ADDENDUM NO. 2

October 27, 2022

Carey Ridge Elementary Addition & Renovation
16231 Carey Road
Westfield, IN 46074

2 WALL SECTION AT WINDOW
SCALE: 3/4" = 1'-0"

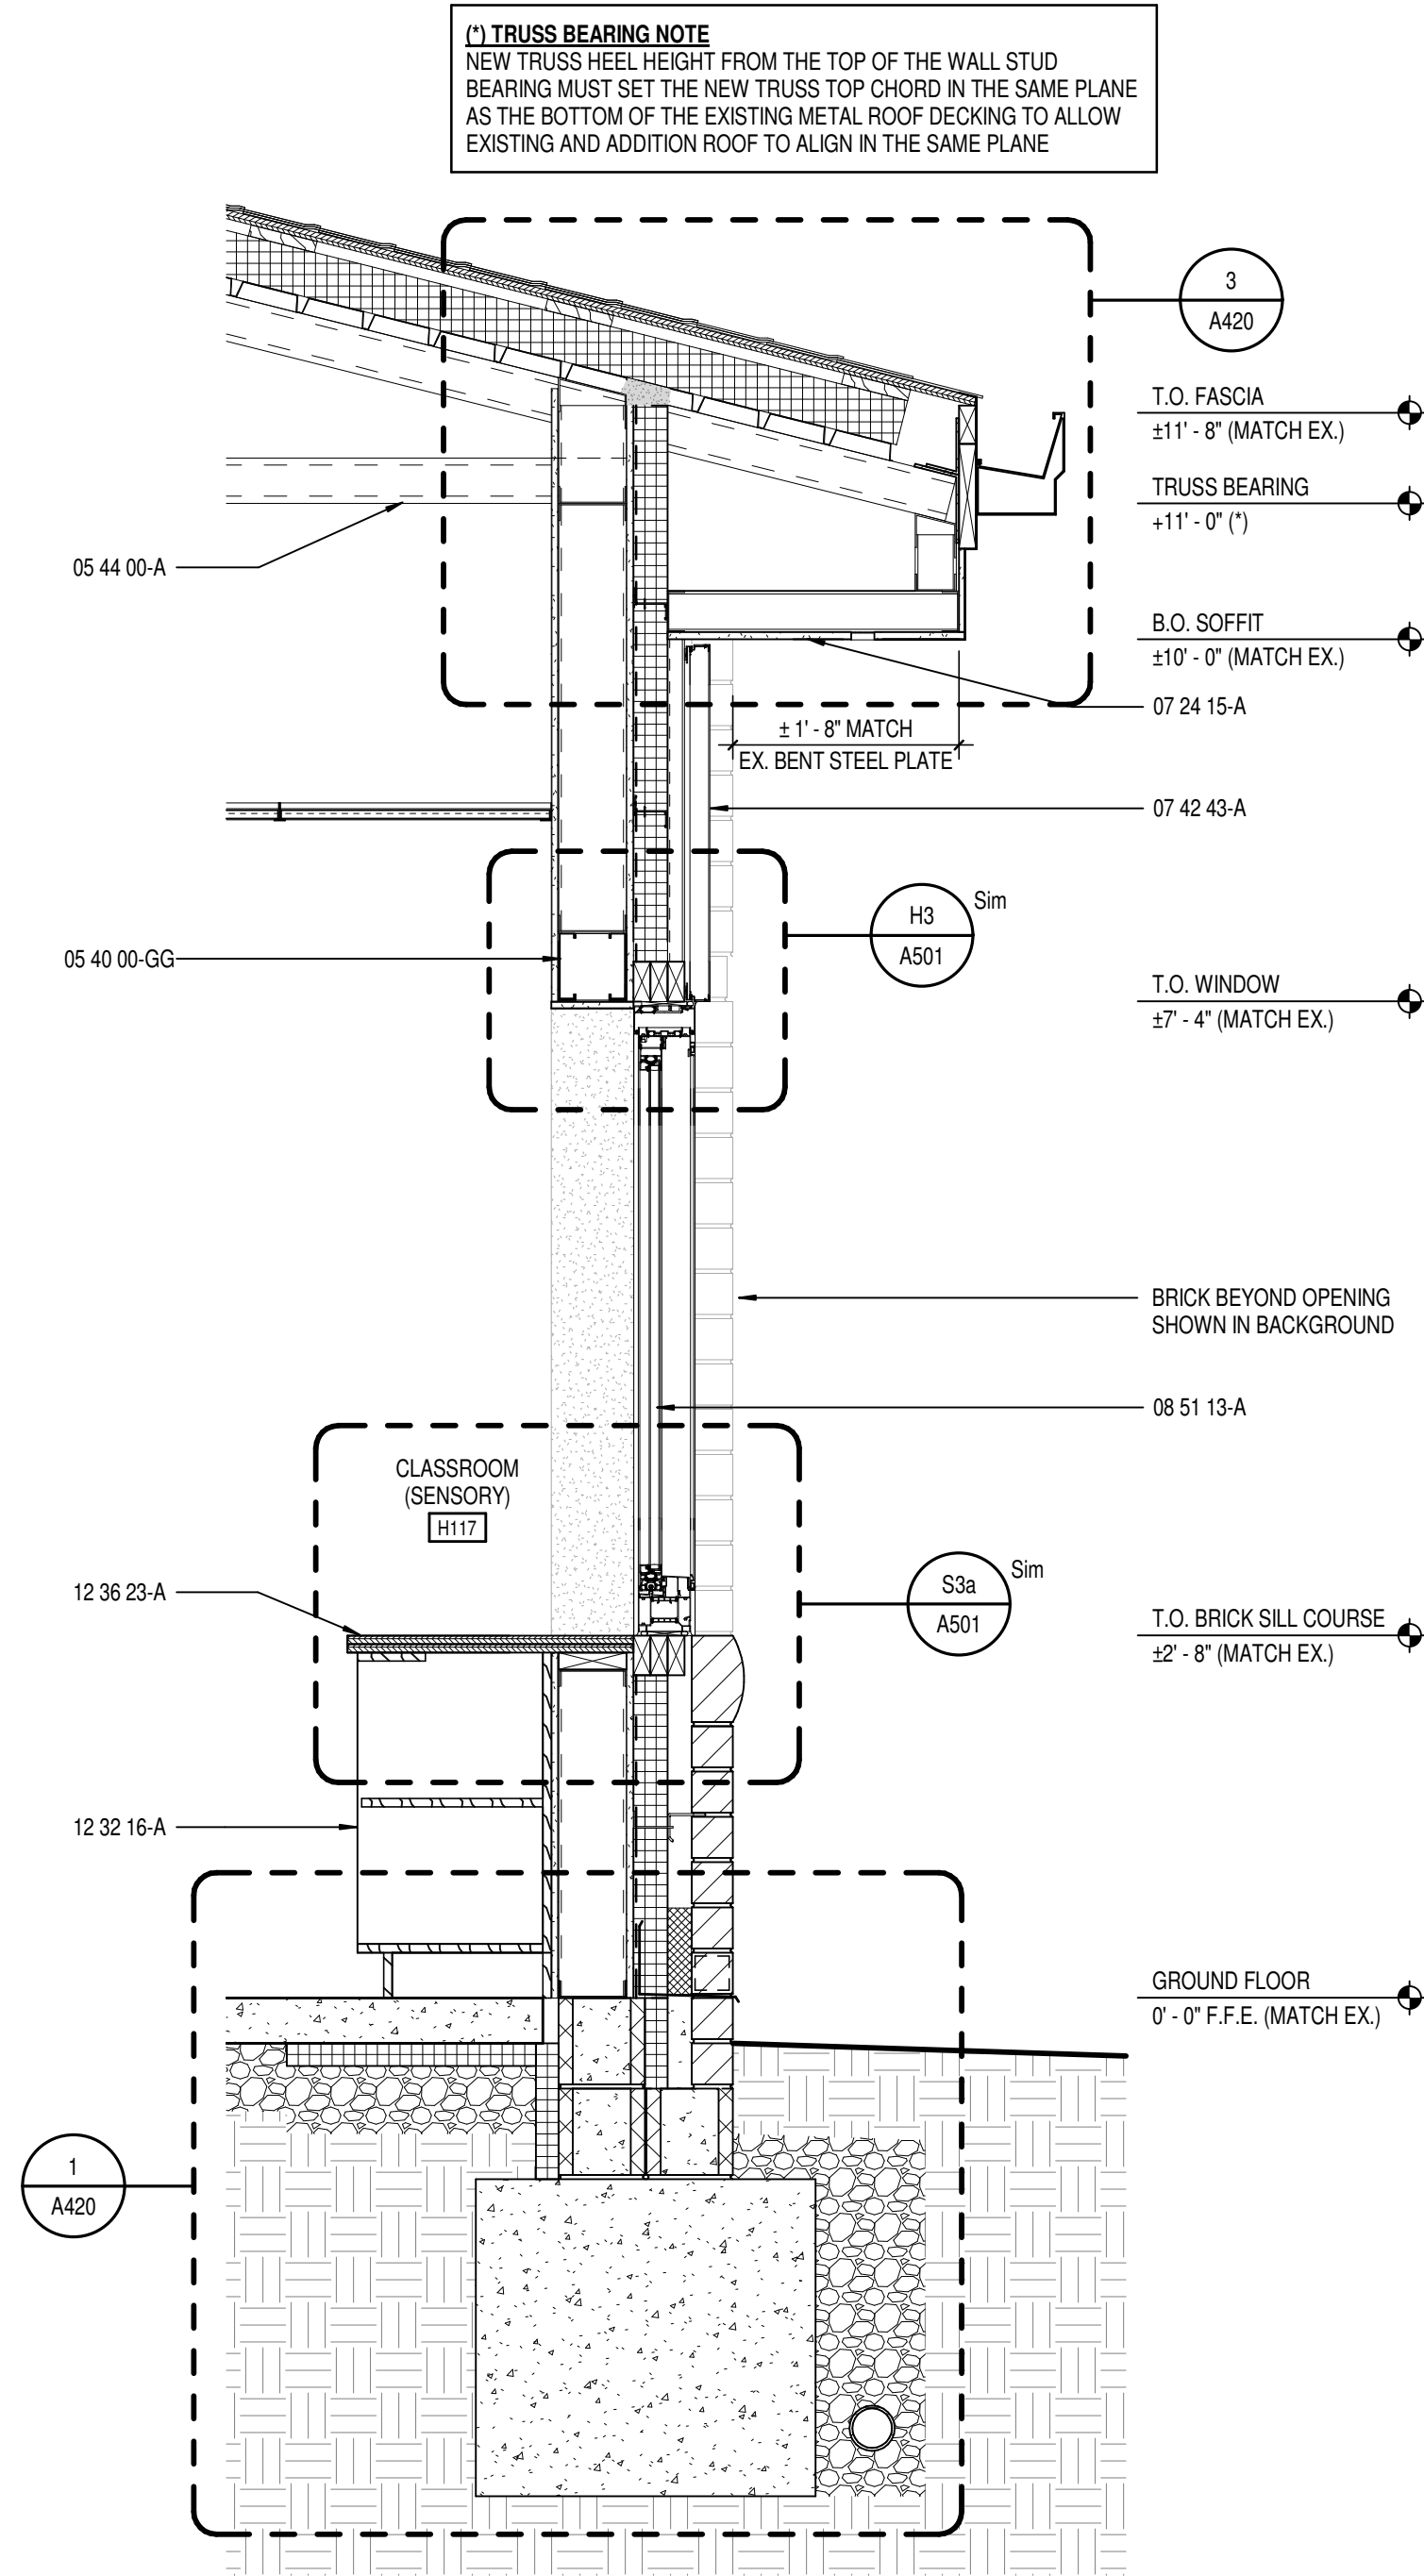
- A. Wall Section 3/A409
1. Removed rake overhang dimension, refer to Section Detail 4/A420 for dimension.
 2. Added note to provide sheet metal water diverter at bottom of lower rake wall roof slope to divert water into gutter.

DRAWING NUMBER
A420

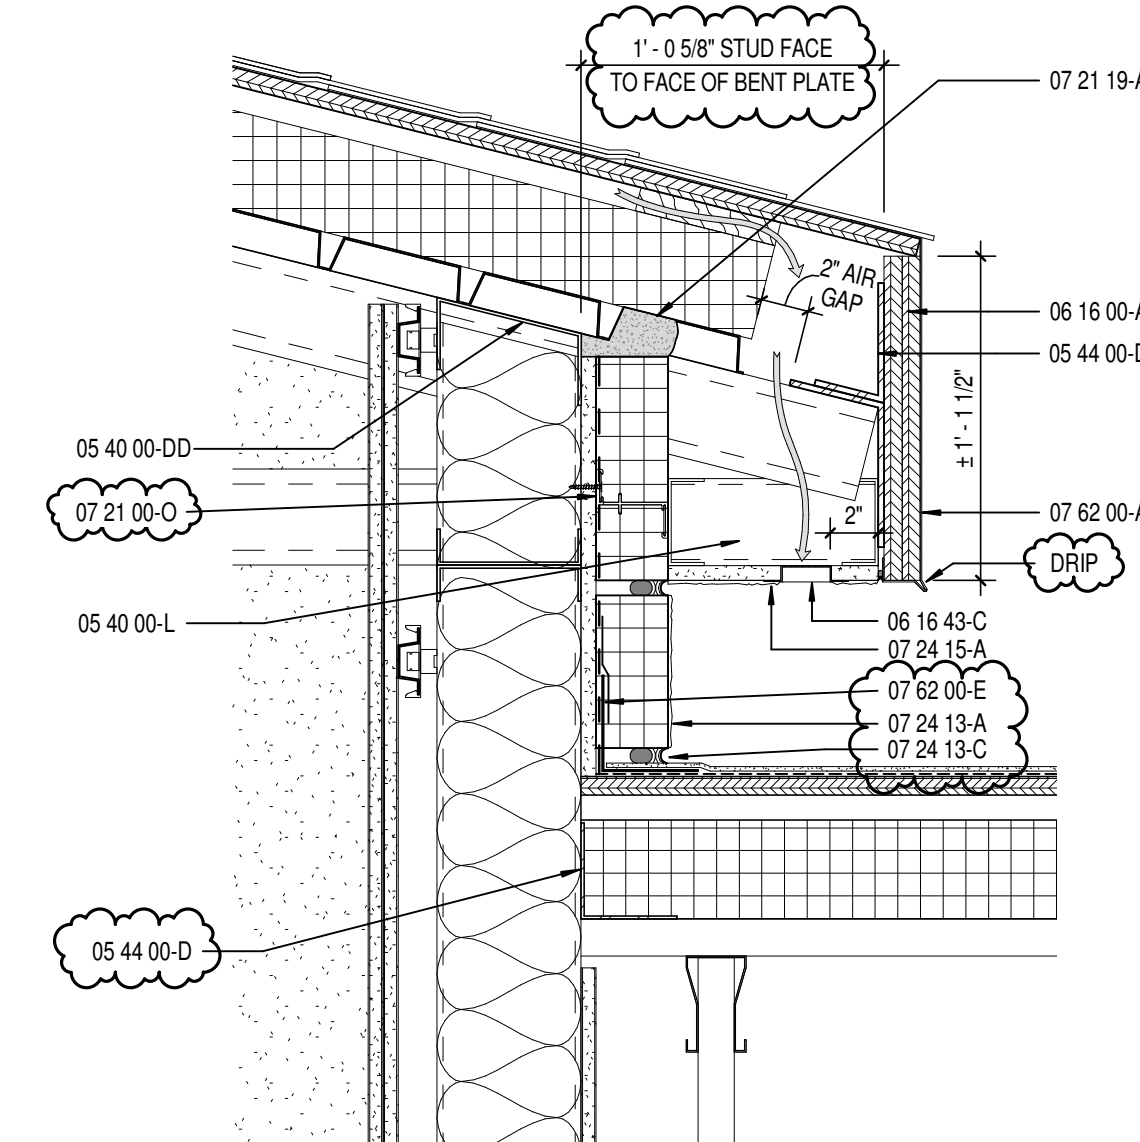
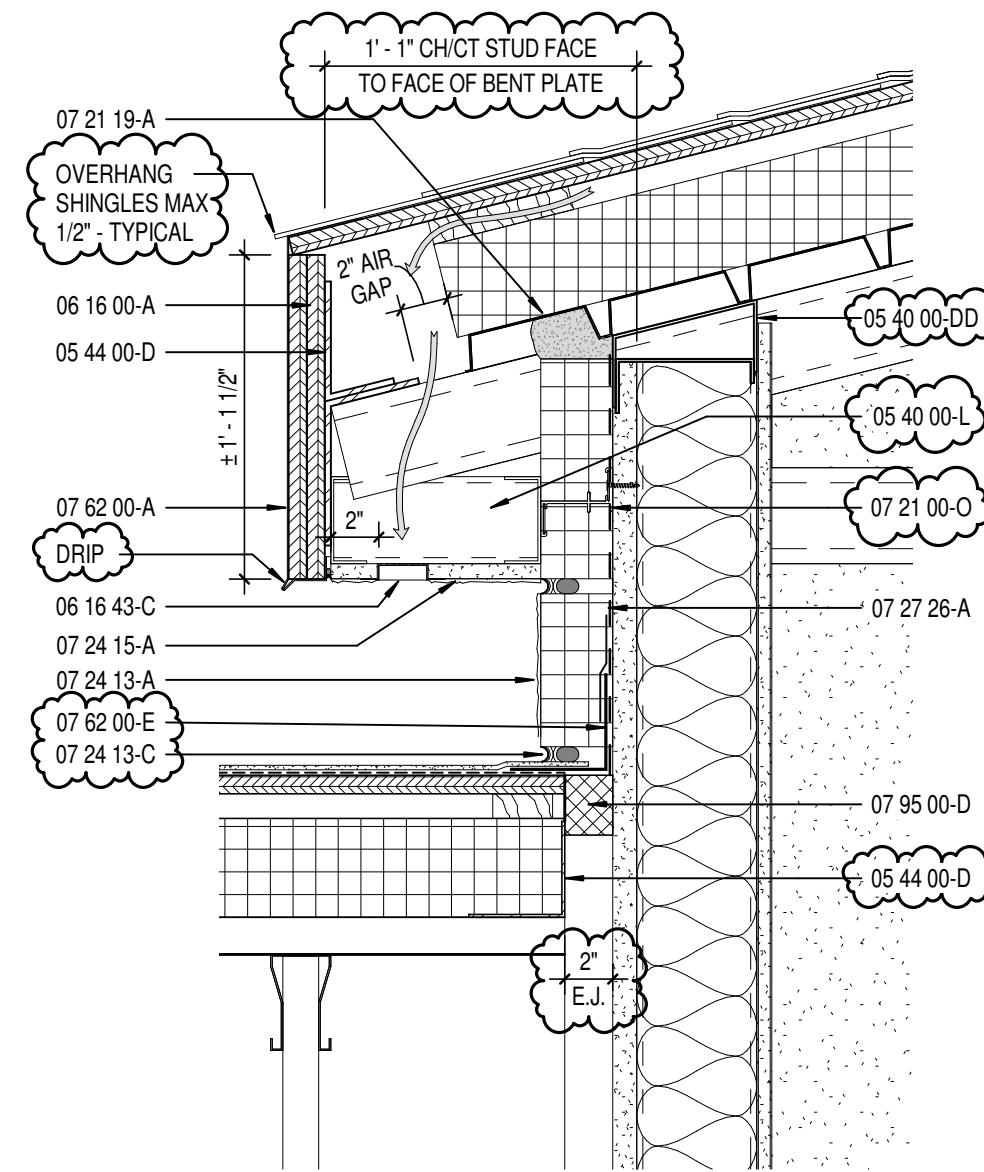
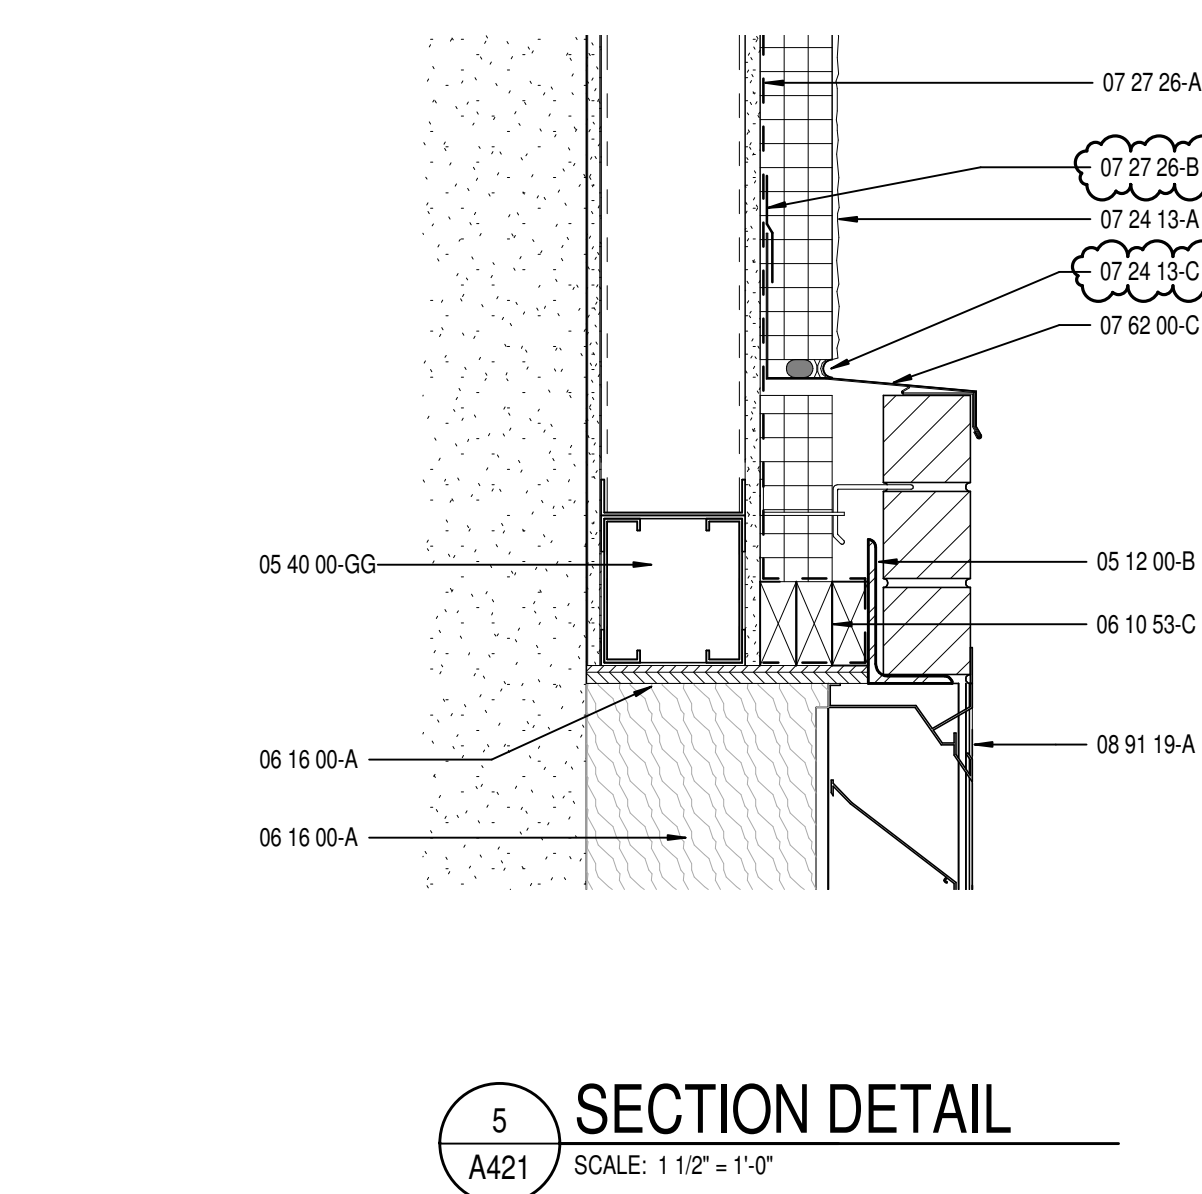
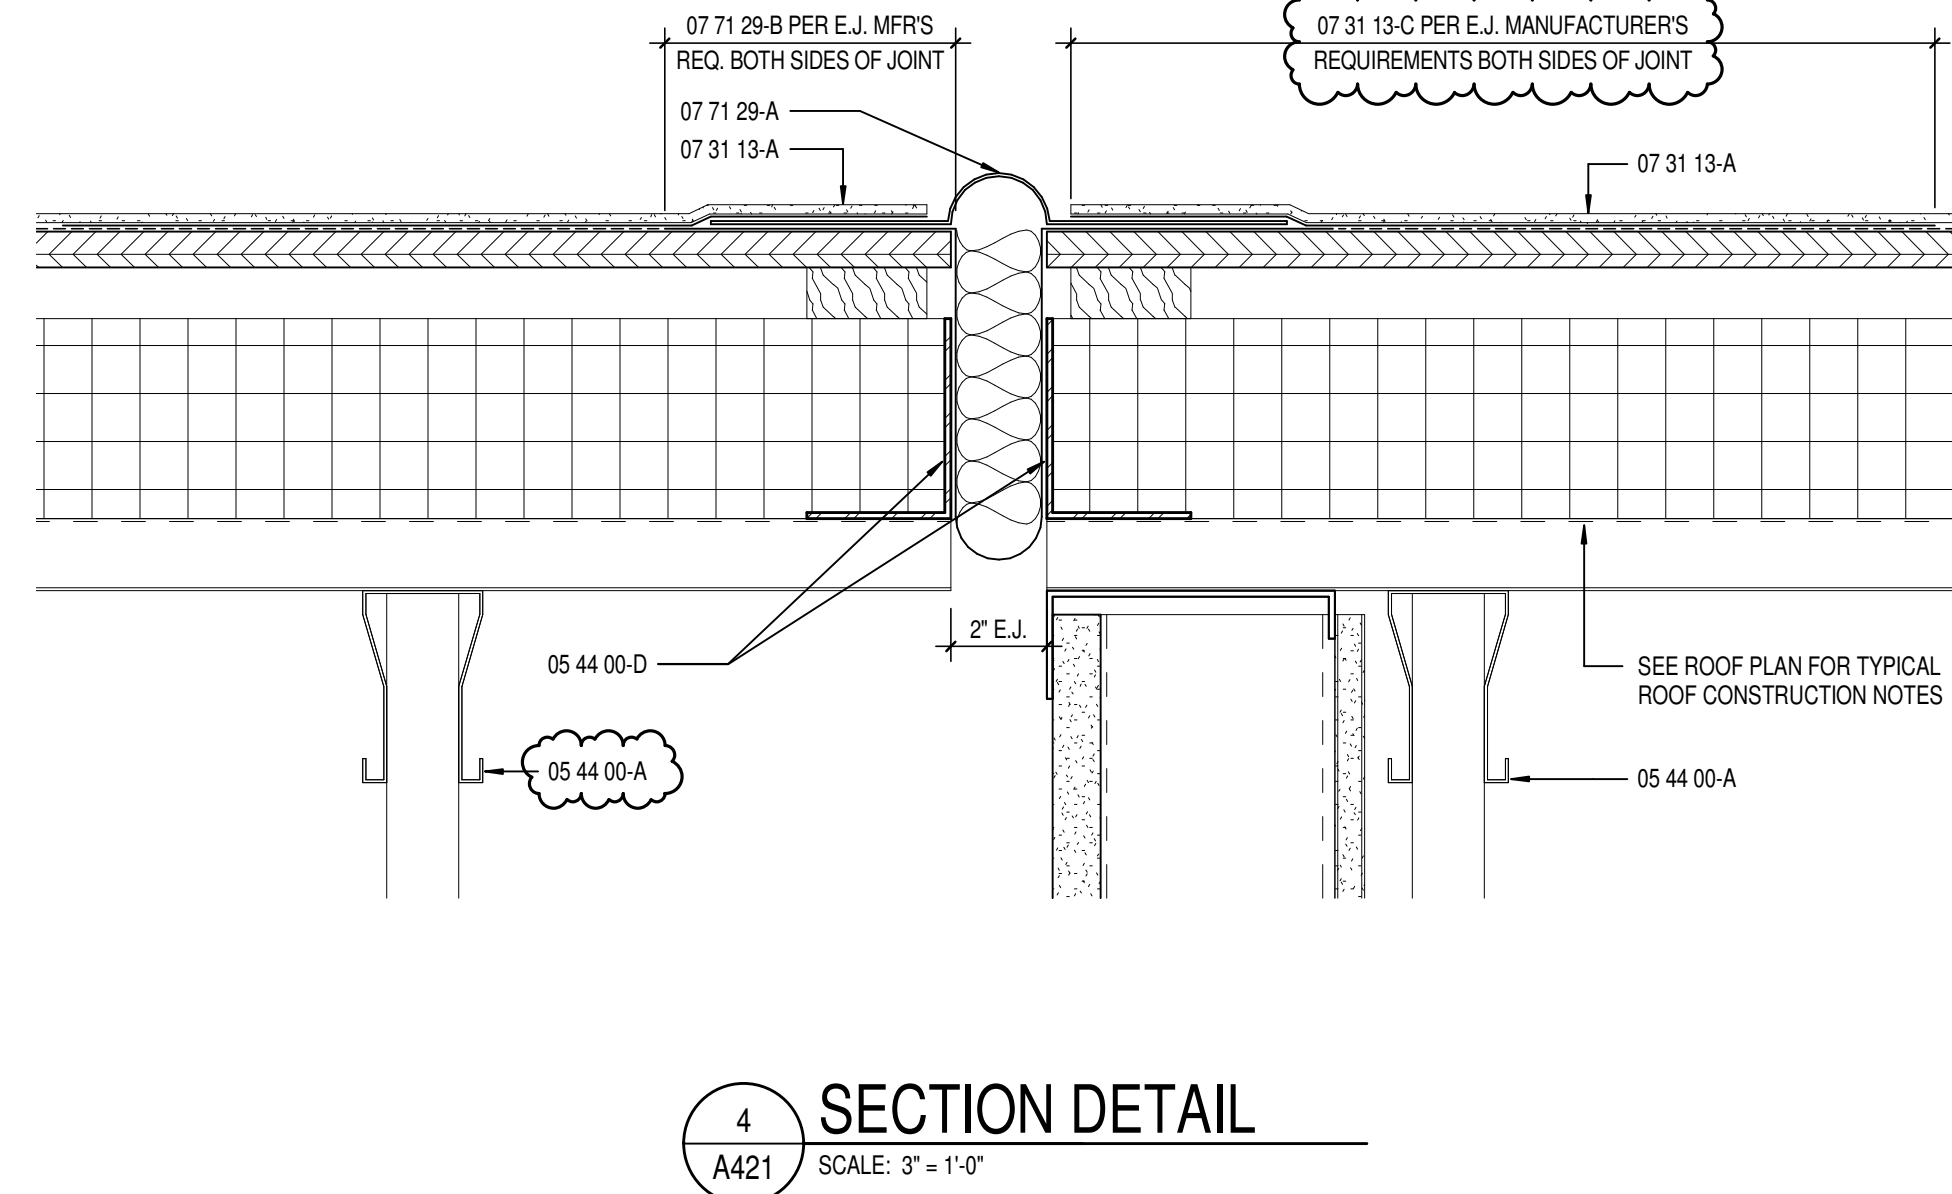
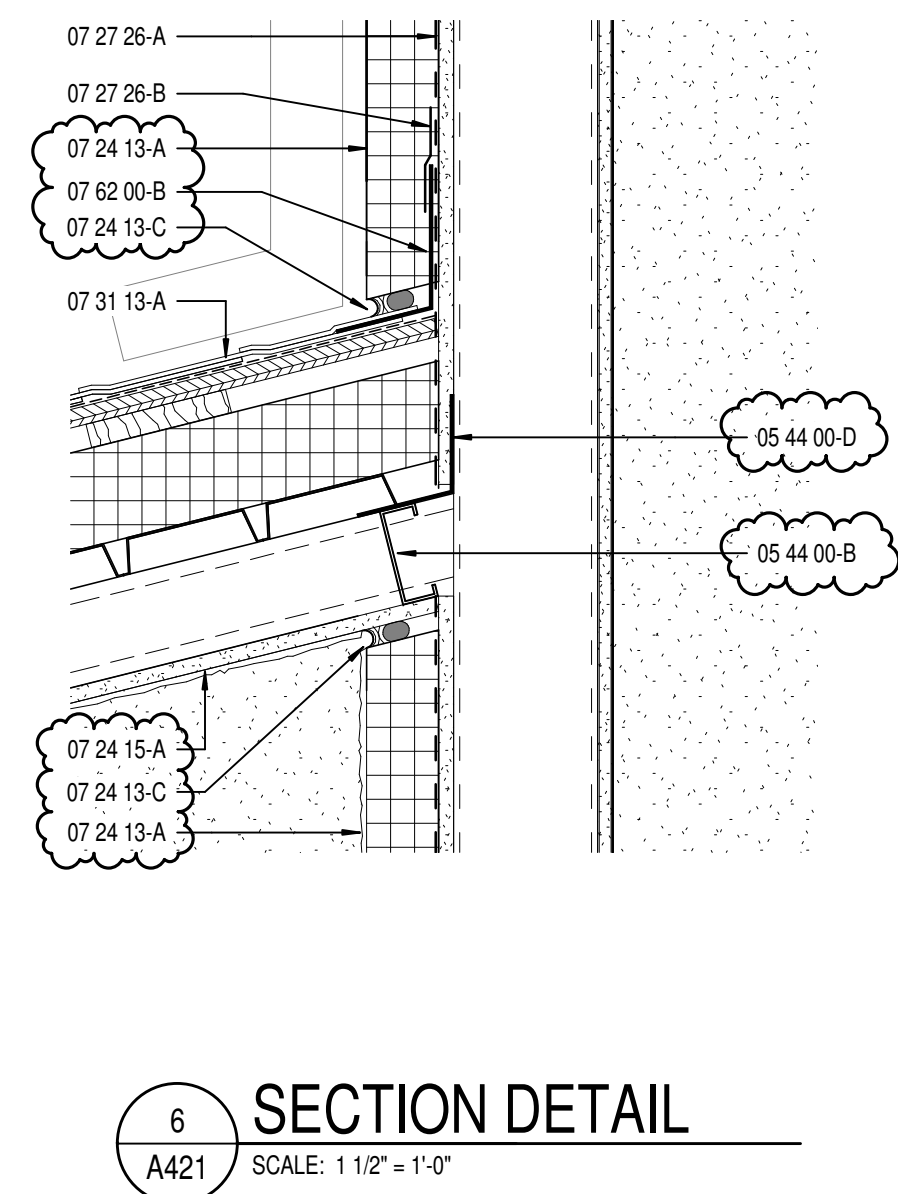
A. Section Detail 3/A420

1. Revised dimensions.

B. Section Detail 3/A420

1. Revised dimensions and keynotes.
